Re: Docket No. Petition 1405 - Horton Cove Circuit Separation Project

Response to CSC-01 Interrogatories dated 06/02/2020 CSC-001, 002, 003, 004, 005, 006, 007, 008, 009, 010

Data Request CSC-01
Dated: 06/02/2020
Q-CSC-001
Page 1 of 1

HORTON COVE RIGHT-OF-WAY CROSS-SECTION XS-2 MONTVILLE, CT

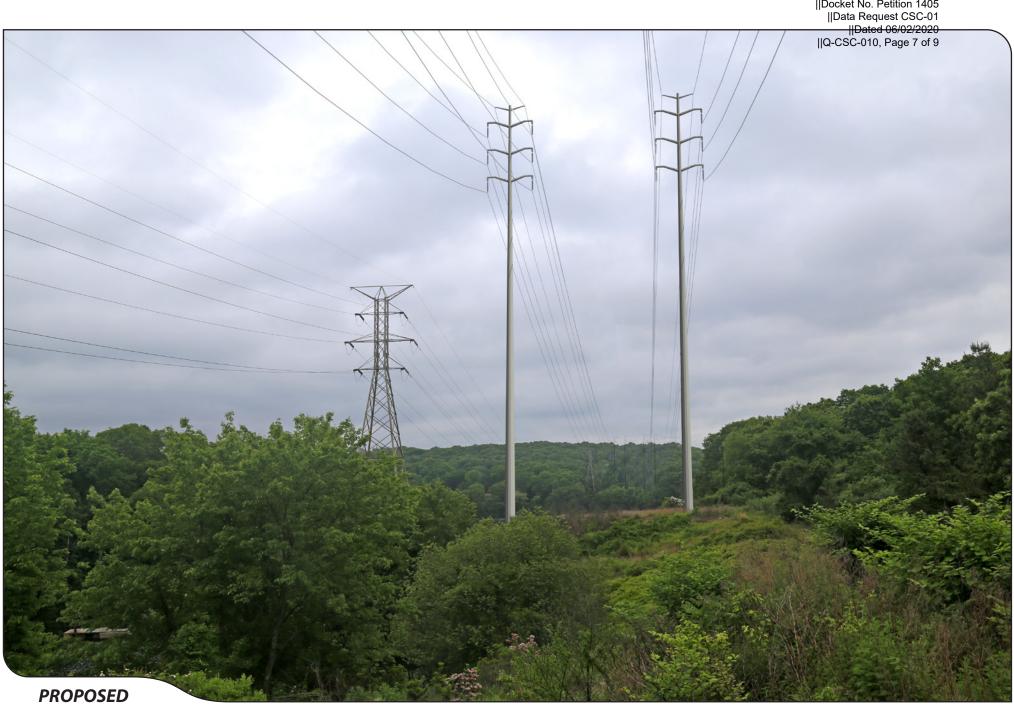
For Drawings XS-1, XS-2 and XS-3, please provide photographic documentation of the existing structures to be removed. Also provide photo-simulations to depict the proposed structures identified on Drawings XS-1, XS-2 and XS-3.

Attached are the photographic documentation of the existing structures and the photo simulations of the proposed structures identified on Drawing XS-1, XS-2, and XS-3.
